**Suncor Energy Cedar Point Wind
Project - Renewable Energy
Approval Amendment
Modification Report**

File No. 160960709

May 2014

Title
 Natural Features- Proposed
 Transmission Line Revision 1

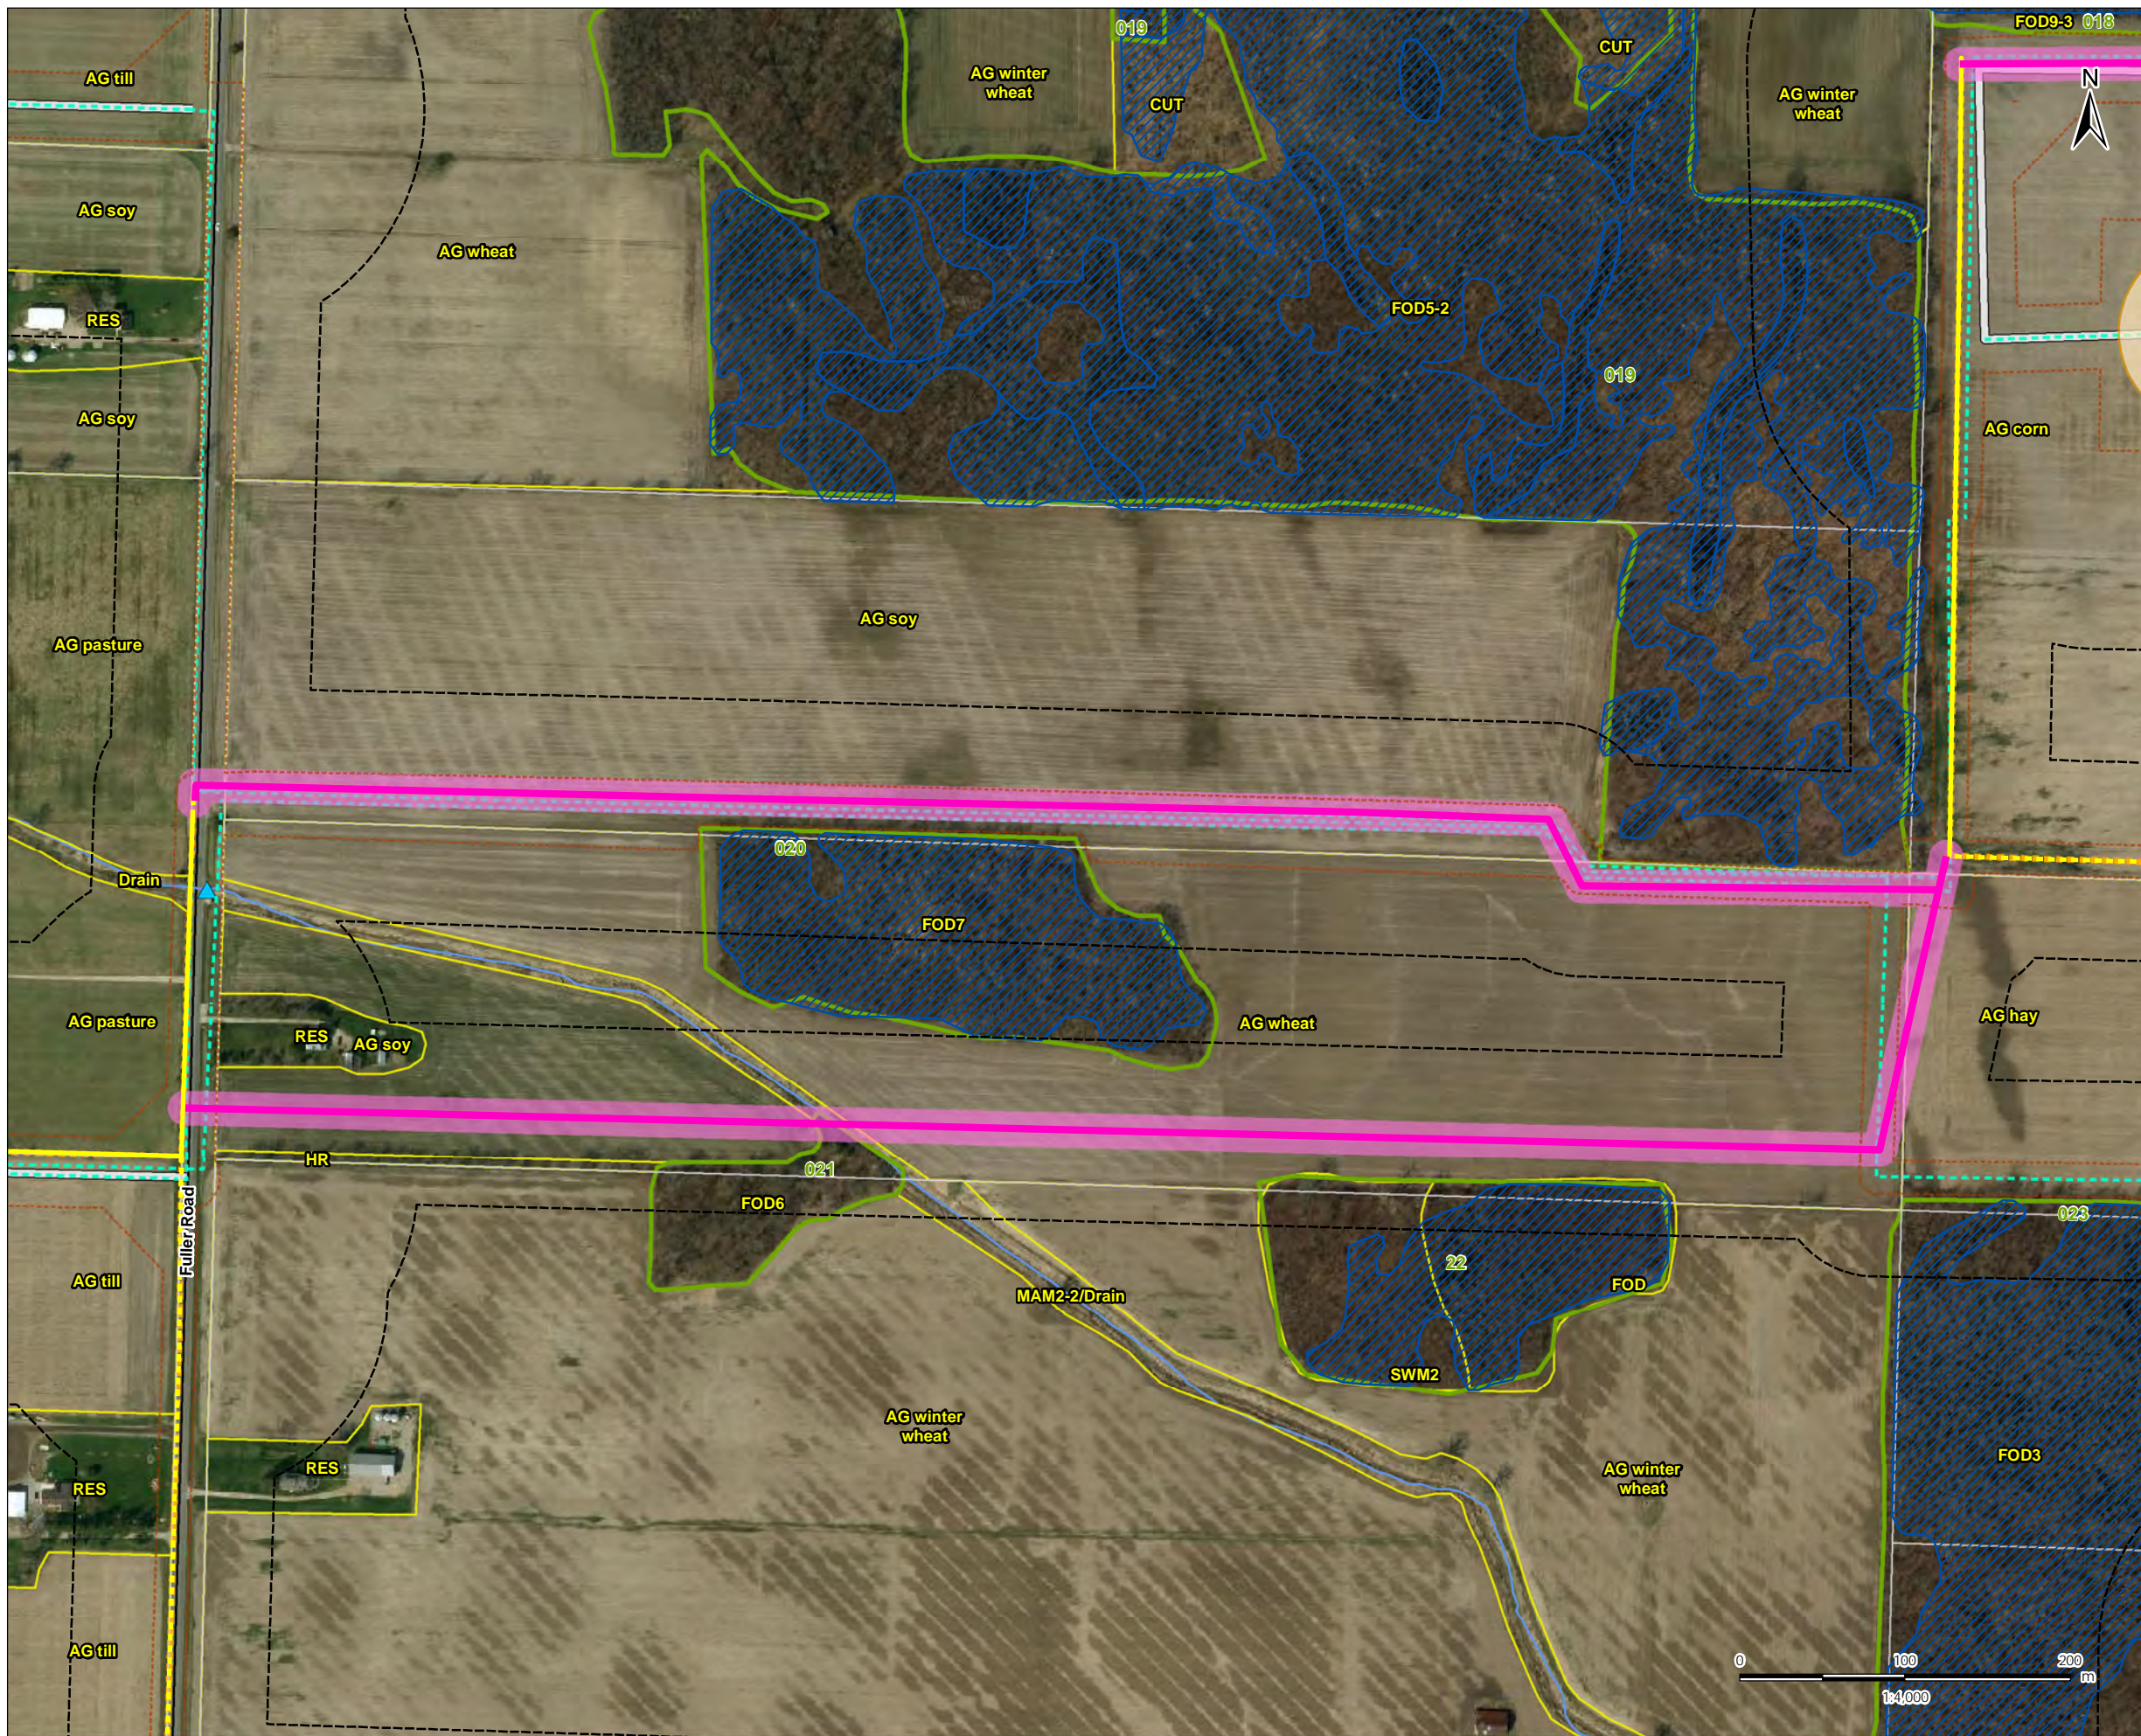
Changes to the location of the overhead transmission line route have been made in the northeast section of the Project. Figures 1.1, 1.2 and 1.3, Attachment 2 show the location of the modified transmission line route.

infrastructure from being located within recently evaluated Provincially Significant Wetland (PSW). Note that only one of the amended transmission line routes will be constructed to avoid Natural Feature 20 as shown in Figure 1.1, Attachment 2.

Two new features will be located within 50 m of the new transmission line route running east from Fuller Rd and north of Cedar Point Line. These features were originally identified as part of the Cedar Point NHA/EIS site investigations but were removed at a later date due to project layout changes. They are shown on Figure 1.1, Attachment 2 as new Features 21 and 22.
